UNITED STATES
NUCLEAR REGULATORY COMMISSION
WASHINGTON, D. C. 20555

January 11, 1993

LICENSEE: Carolina Power & Light Company
FACILITY: Brunswick Steam Electric Plant, Units 1 and 2
SUBJECT: SUMMARY OF MEETING HELD TO DISCUSS POSSIBLE CONCERNS WITH THE
BRUNSWICK STEAM ELECTRIC PLANT, UNITS 1 AND 2, CONTROL BUILDING
EMERGENCY AIR FILTRATION SYSTEM CHLORINE DETECTION LOGIC

CONTROL BUILDING EMERGENCY AIR FILTRATION SYSTEM - SINGLE FAILURE 1

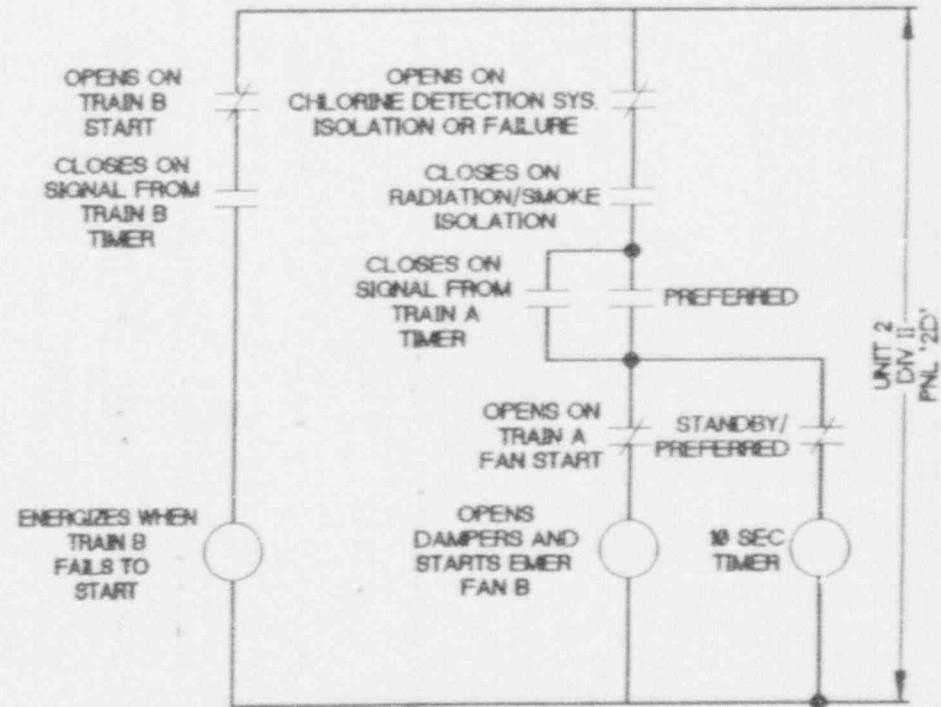
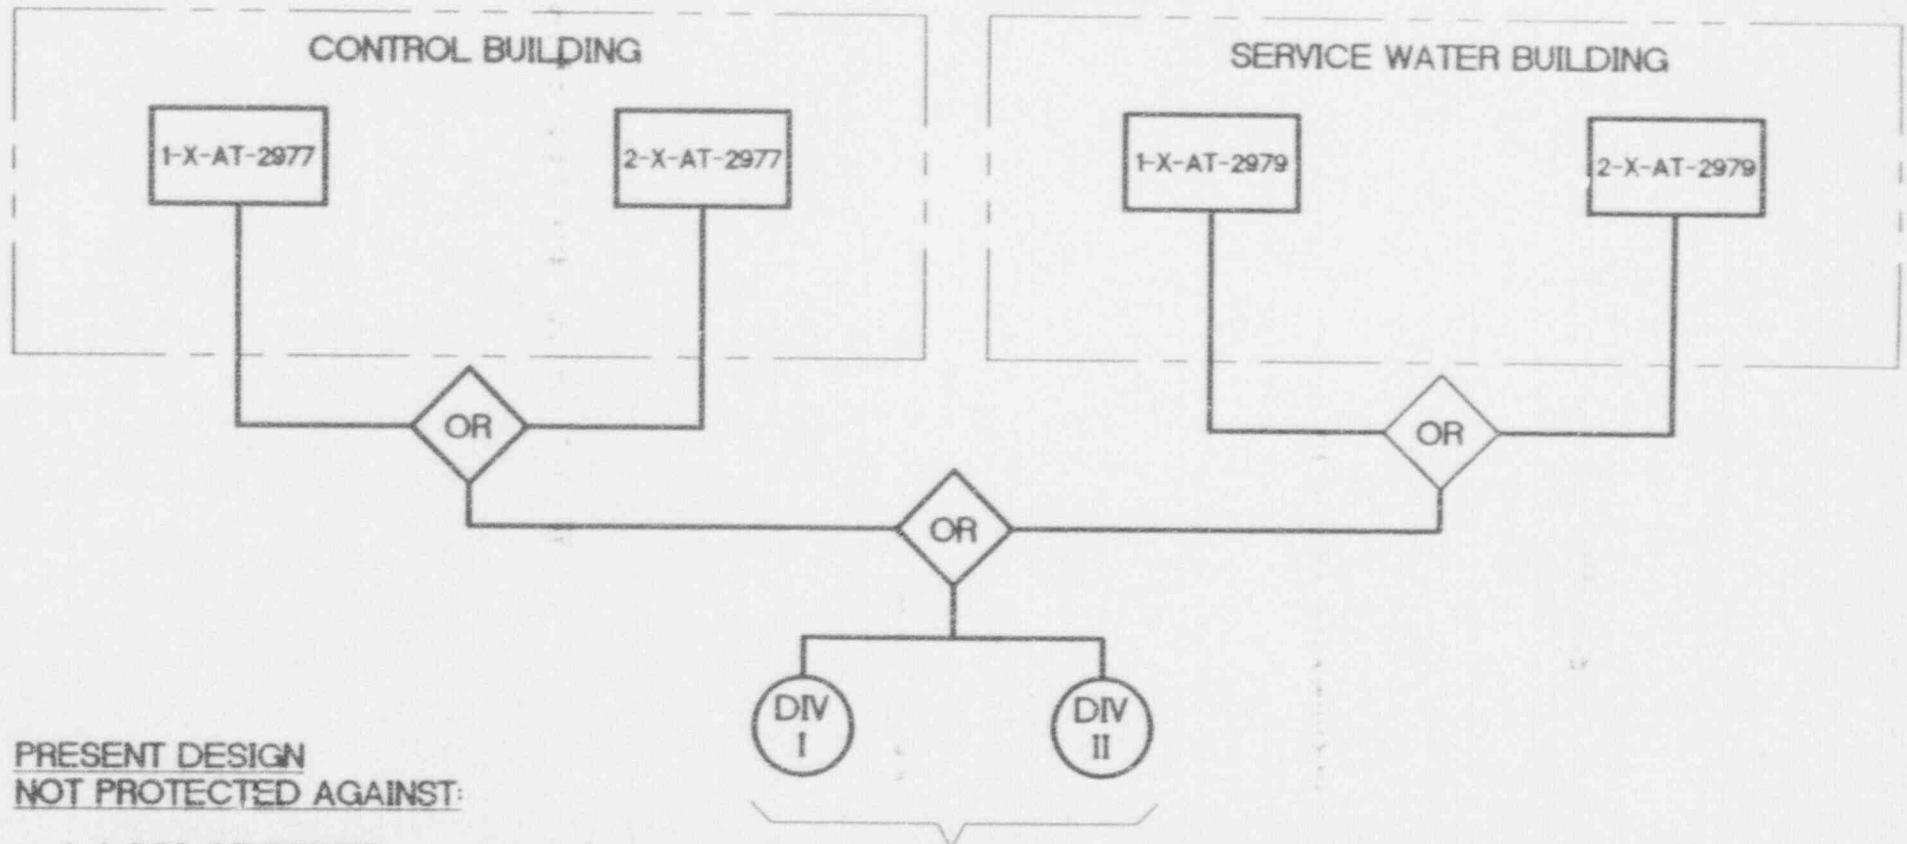
PRESENT DESIGN
NOT PROTECTED AGAINST:

- 1- LOSS OF POWER
- 2- INADVERTANT ISOLATION (SPURIOUS)
- 3- SINGLE COMPONENT FAILURE

SINGLE DETECTOR ISOLATES
BOTH TRAINS OF
CBEAF

CONTROL BUILDING EMERGENCY AIR FILTRATION SYSTEM - PHASE I

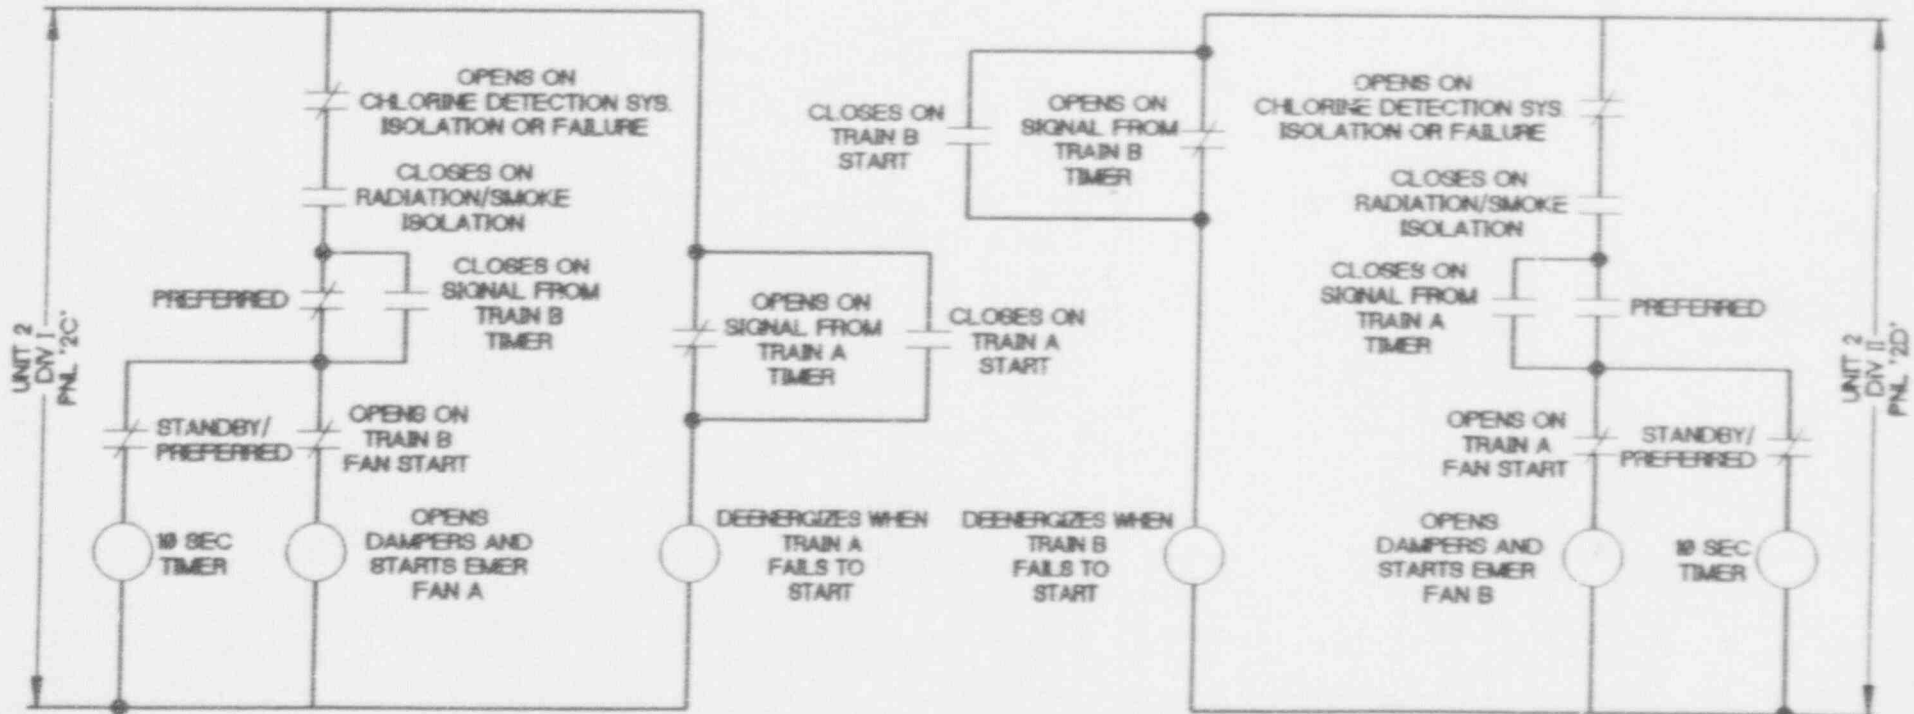
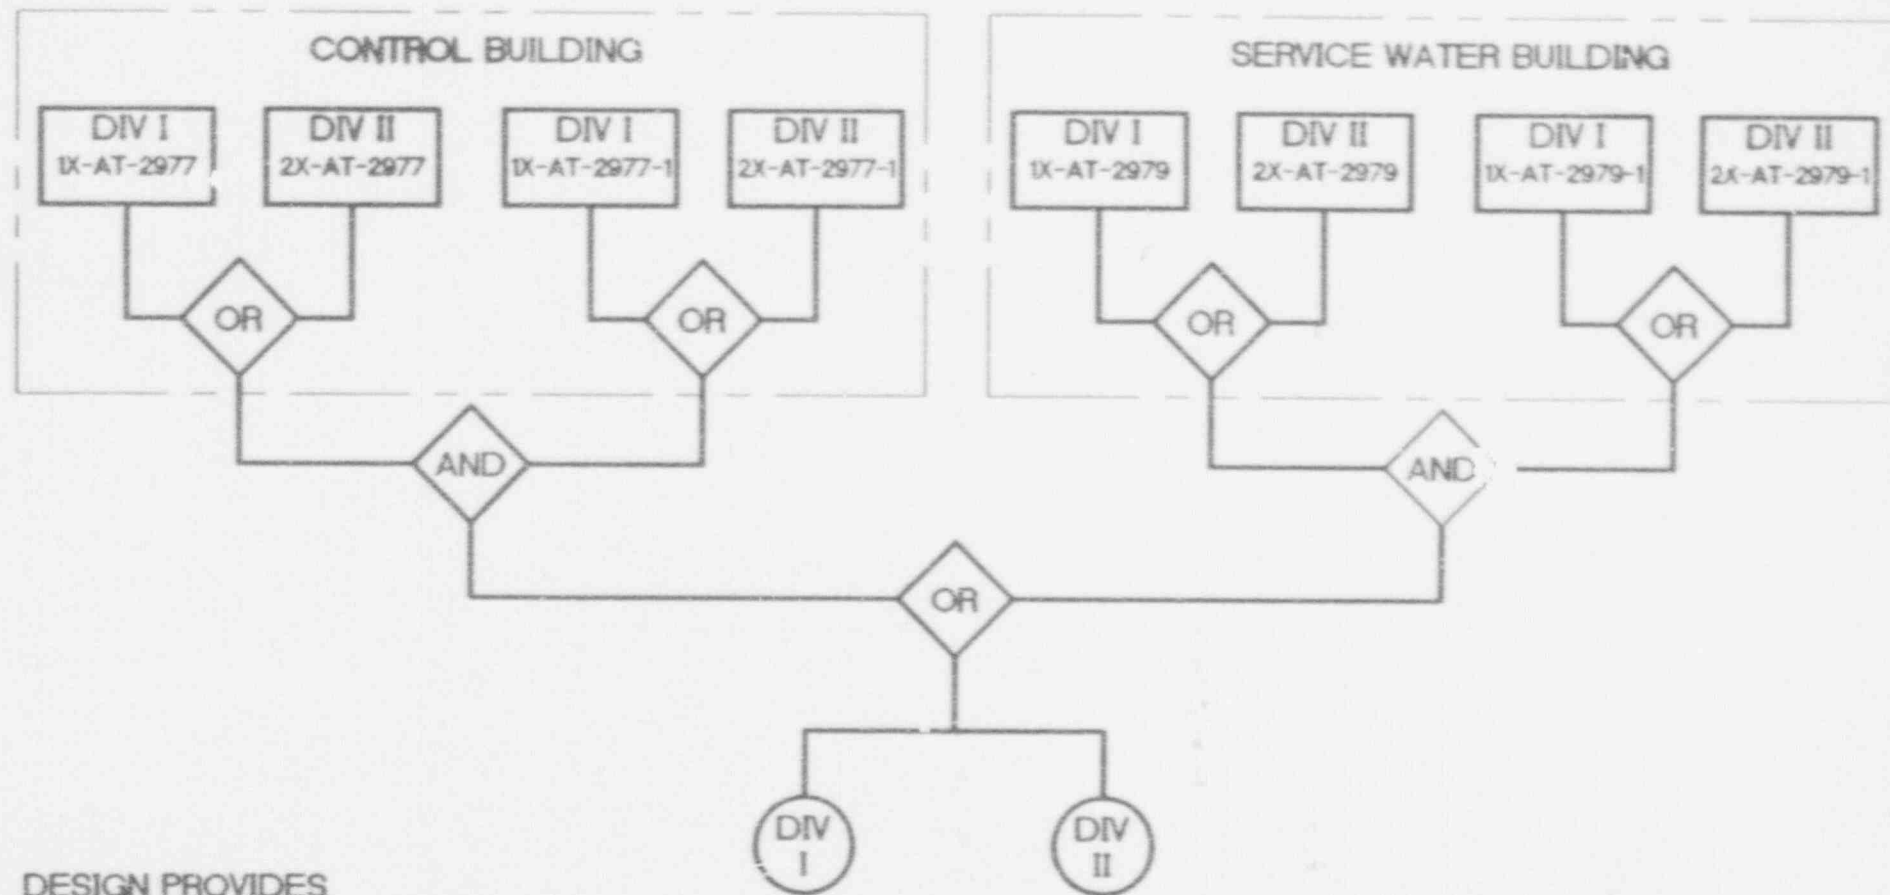
CONTROL BUILDING EMERGENCY AIR FILTRATION SYSTEM PROPOSED CHANGE

DESIGN PROVIDES
PROTECTION AGAINST:

- 1- LOSS OF DIVISIONAL POWER
- 2- INADVERTANT ISOLATION (SPURIOUS)
- 3- SINGLE COMPONENT FAILURE
- 4- FAILURE TO DETECT CL₂

EACH ISOLATES
BOTH TRAINS OF
CBEAF
